Site Design Consultants

Subject: Notice of Incomplete Application - Permit Application Number NAN-2015-00700-WOM
Village of Croton-on-Hudson

ELLIOTT WAY IMPROVEMENTS

C - 101

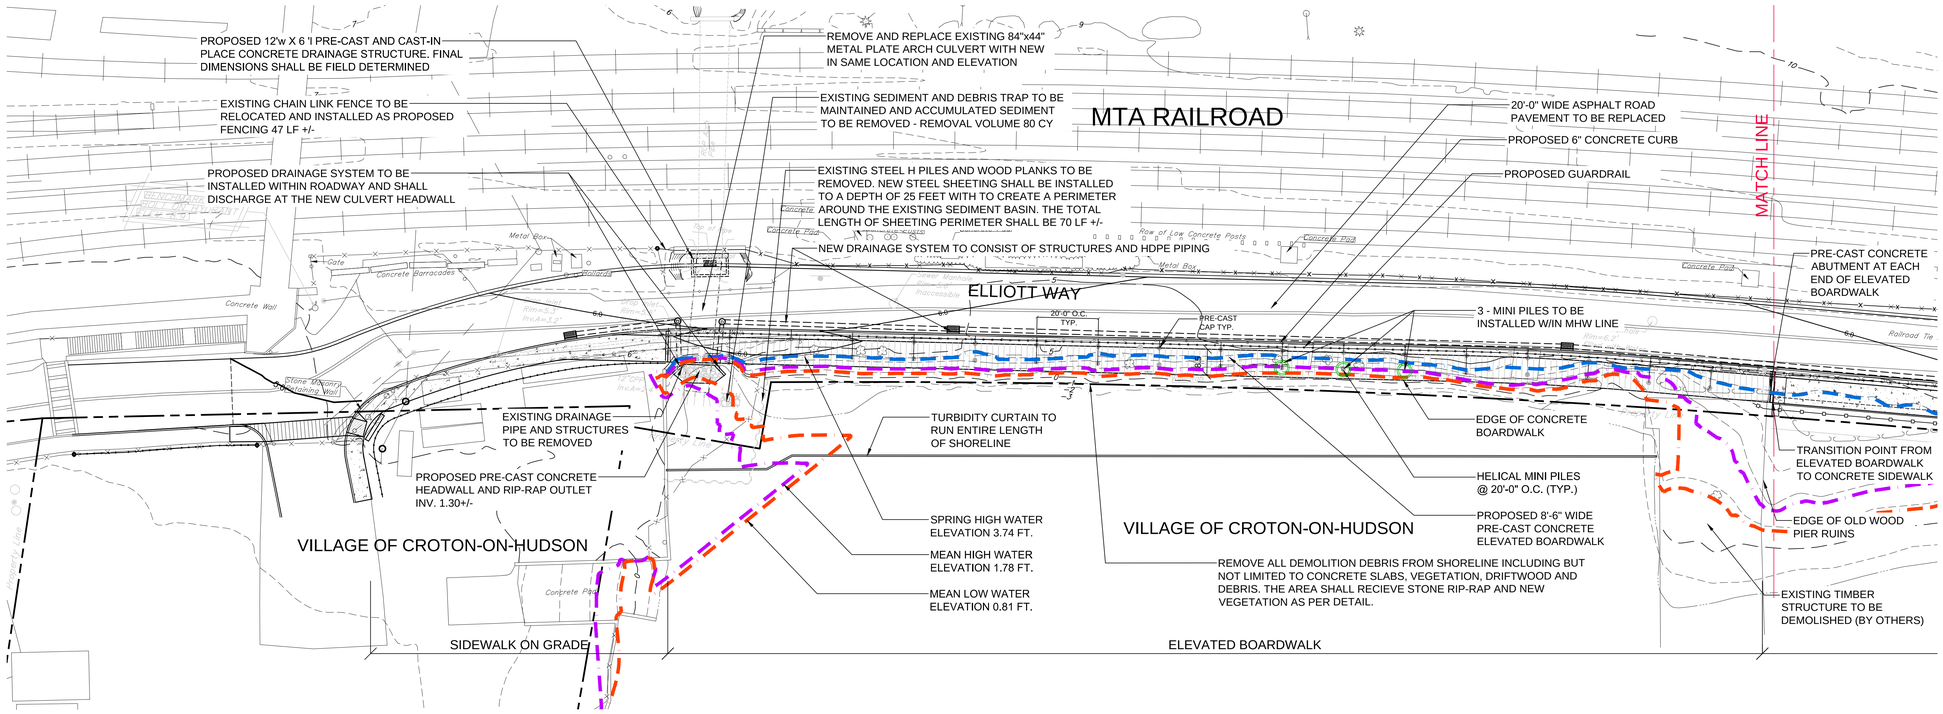
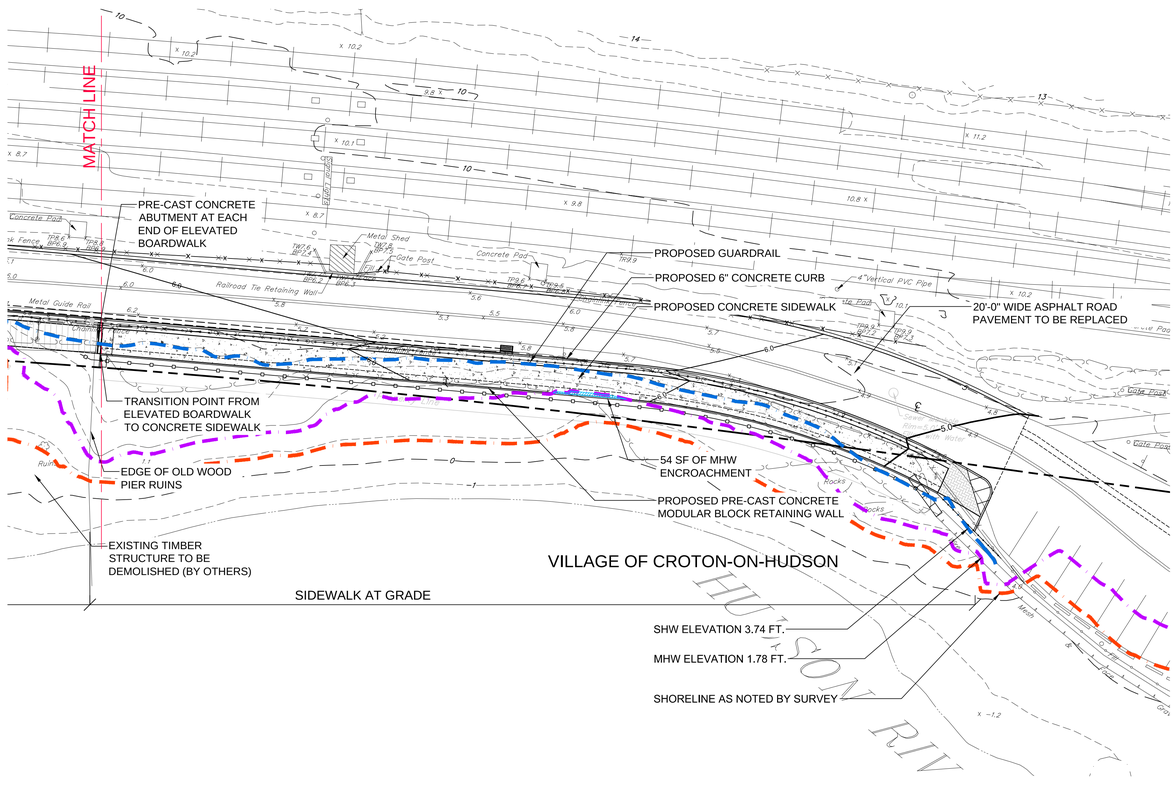
3. Sheet C-101 shows the sheet piling for the sedimentation basin but there is no cross-section showing the detail. A narrative should be included to explain the necessity of the sheet piling. In addition, I would want to know the methodology for installing the sheet piling.

The existing sedimentation basin is part of the storm water management system for the Village of Croton-on-Hudson. The 8' metal arch pipe which runs below the Metro North tracks, discharges storm water into the Hudson River at the Croton Yacht Club (Photo #9). The sediment basin was constructed by the Village of Croton-on-Hudson to retain debris and sediment caused by storm water discharge. The existing sedimentation basin is constructed of vertical H piles with horizontal timber lagging and large precast concrete blocks (Photo #10). Under this project the existing steel H piles, horizontal timber lagging and concrete blocks would be removed and replaced with new steel sheeting (Z sections). The steel sheeting would be installed using either vibratory or press method. The press method is the preferred method as it would eliminate ground vibrations. We anticipate that that the sheet piles will be approximately 25 - 30' in total length. See typical detail.

C - 103

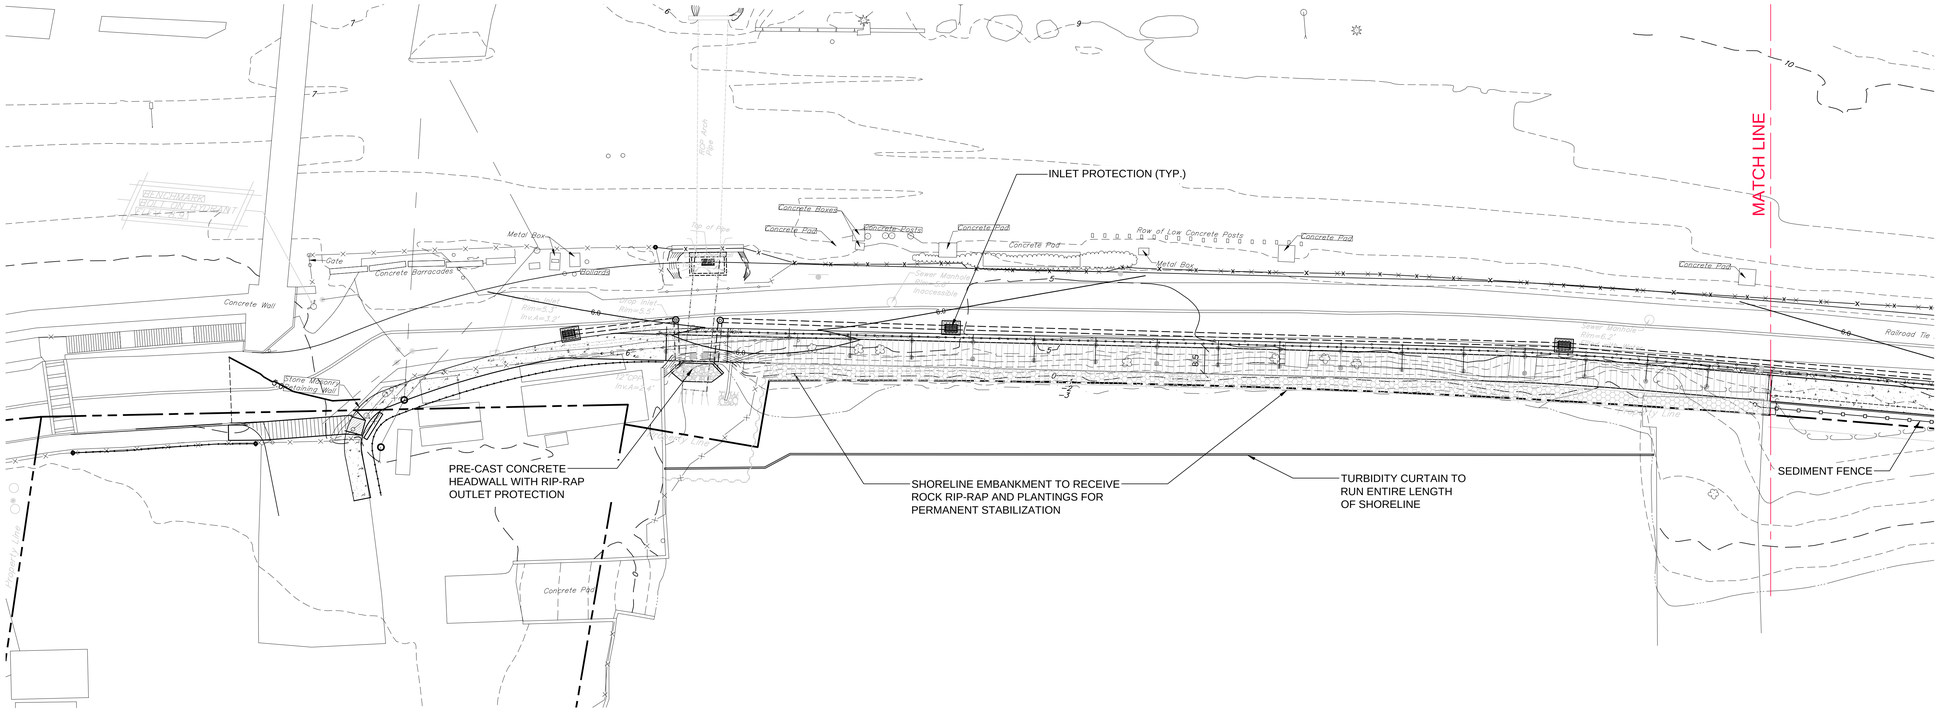
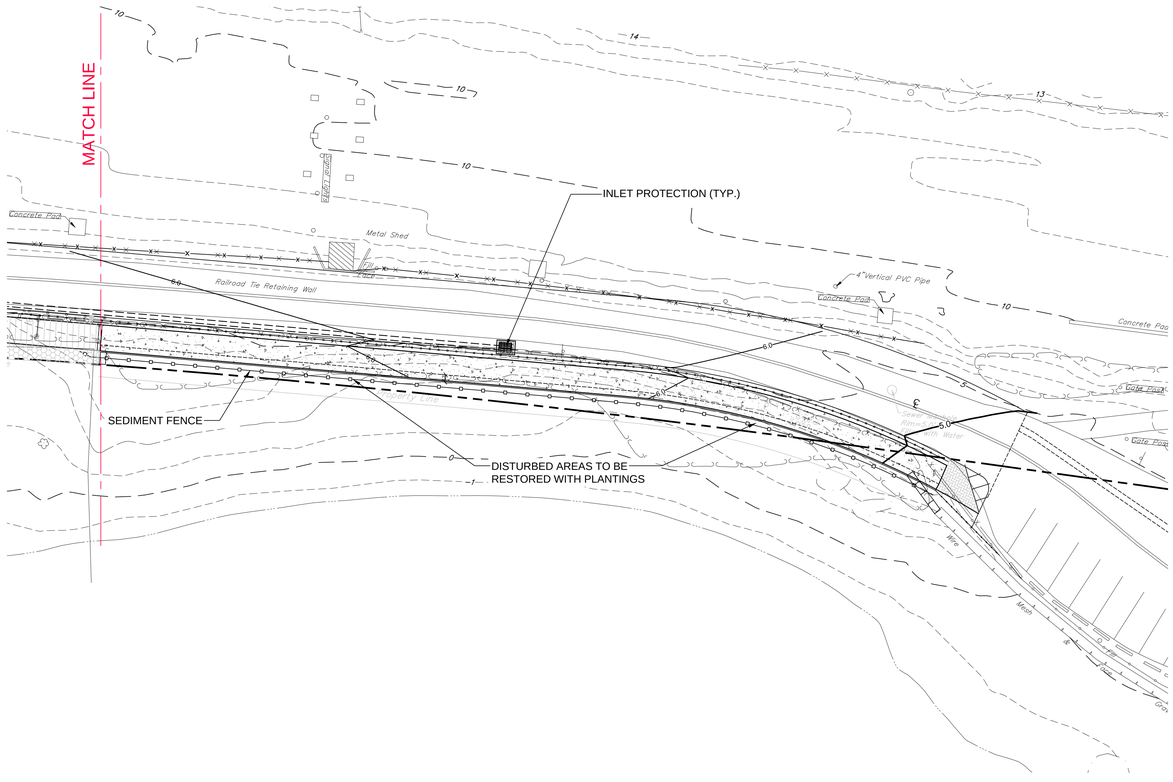
4. Sheet C-103 has a turbidity curtain and the curtain on detail sheet C-501 shows a curtain that is only five feet long. If a turbidity curtain will be used on site it should goes from the surface of the water down to the bed of the river.

The detail shown on Sheet C-501 was for illustration purposes. The turbidity curtain will be approximately 300 feet long and will vary in depth. The turbidity curtain will start at the water surface and extend down to the river bottom. The drawings have been corrected to reflect this.

C - 104

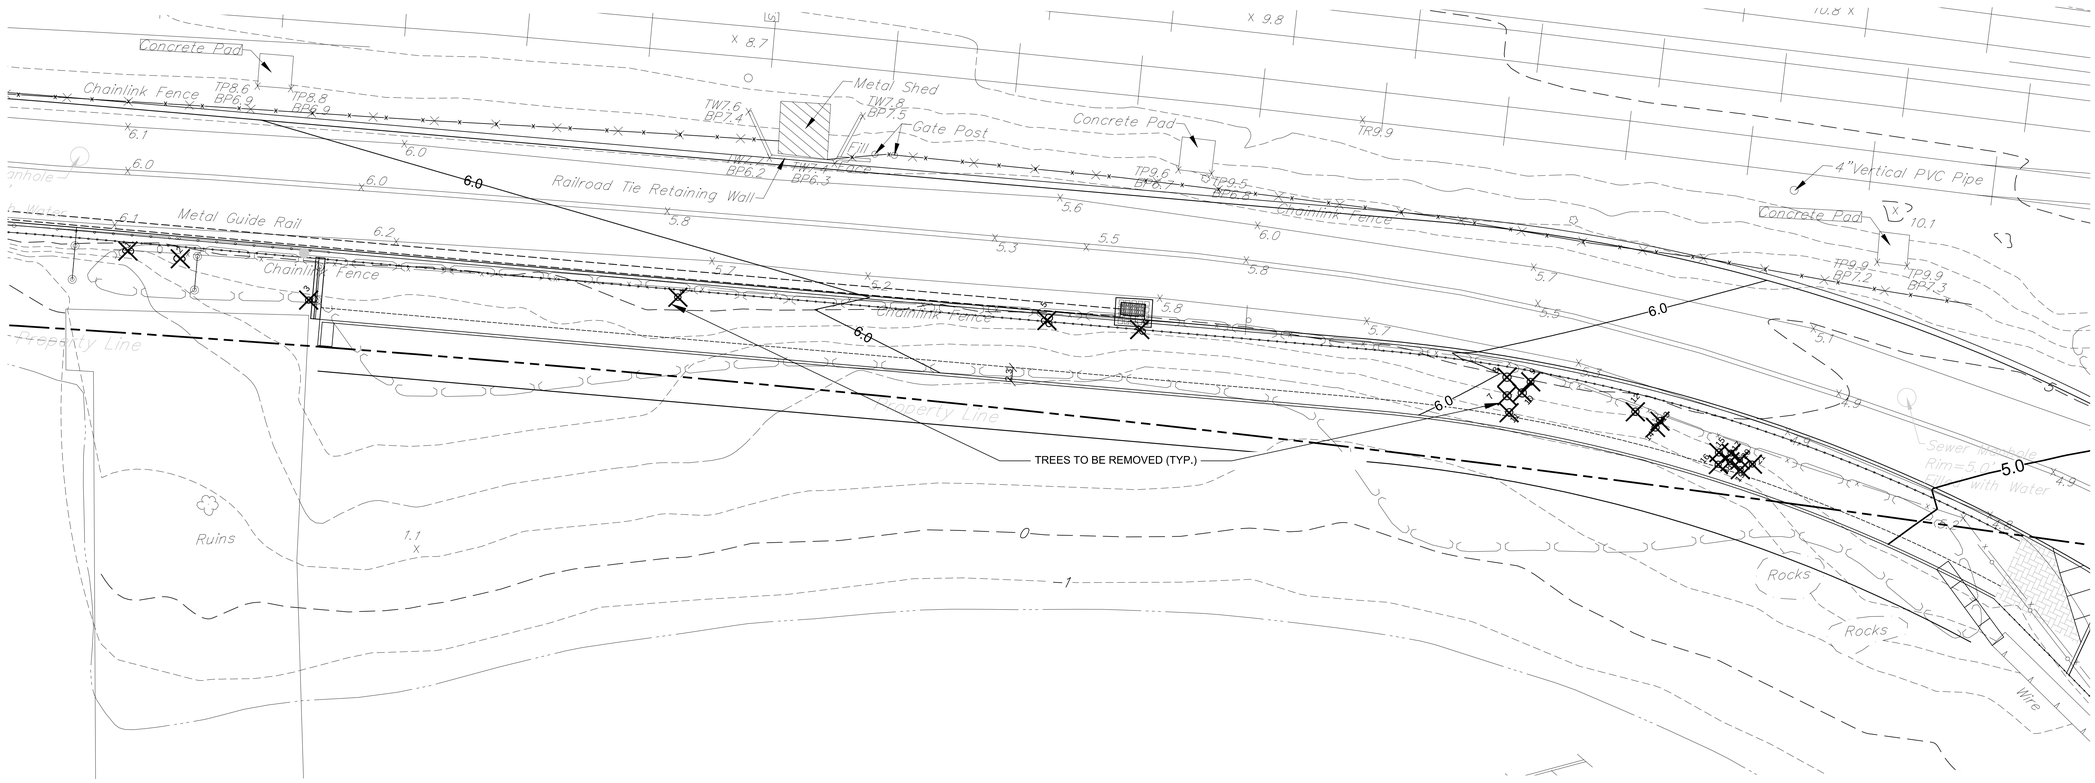
5. Sheet C-104 shows that the new concrete walkway is encroaching into the Mean High Water area. This would cause fill below Mean High Water. The design should be assessed to see if there is an alternative design for a walkway that does not cause fill below mean high water.

The purpose of this project is to create a safe pedestrian access link along Elliott Way. Currently, there is no defined walkway that would allow for safe pedestrian access to the north. Elliot Way is extremely unsafe. Pedestrians walk, run, and bike along this narrow single lane road. This stretch of narrow road is also at times heavily used by both passenger vehicles, and commercial traffic. There is limited visibility, lighting and no delineated walkways. The proposed 8'-6"wide walkway will create at best, an 8'-0" wide (clear) path for the public. This width will only allow for two (2) 4'-0" travel lanes. The travel lanes are confined by the railing along the water side and the guide rail on the roadway side. The 8'-0" width is consistent with the existing path to the south and north end of the project. Narrowing of the proposed walkway would limit access and create an unsafe condition. The walkway cannot be shifted to the east, as it is bound by the Metro North Railroad tracks. Alternate construction methods were examined and were deemed inadequate as they would cause more disturbance to the Hudson River.

S-2 SHORELINE PROTECTION DETAIL
NOT TO SCALE

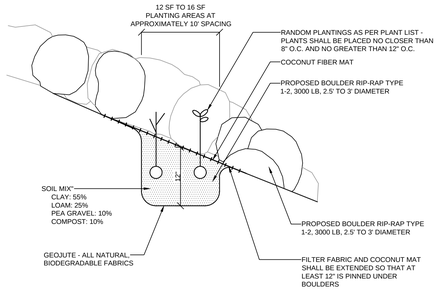
6. Sheet C-105 - There is a detail showing that vegetation will be planted in between rocks. I want to encourage the plantings but I would prefer that a plant list was created so that I had some assurances that the plan will be implemented with success.

A planting schedule has been attached (Table II) for your review and will is included on drawings.
